Wetland Application 19-0181 Re:

401 Water Quality Certification Application 19-141

FERC Project Number 14633

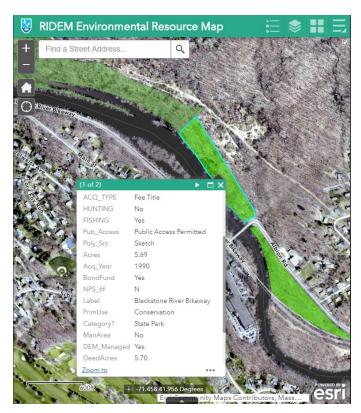
Recreational opportunities abound onsite. According to the RIDEM Environmental resource map (screenshot depicted) the property proposed for development is owned by the State of Rhode Island, acquired in 1990 through bond funding with conservation designated as its primary use. It is a popular area for hiking and the town of Cumberland maintains a nearby walking trail. It is adjacent to Cumberland Hill Conservation Area (99 acres of open space conservation land) as well as additional conservation land south east of Albion Road. These lands are intended to protect open space and access for both active and passive recreation.
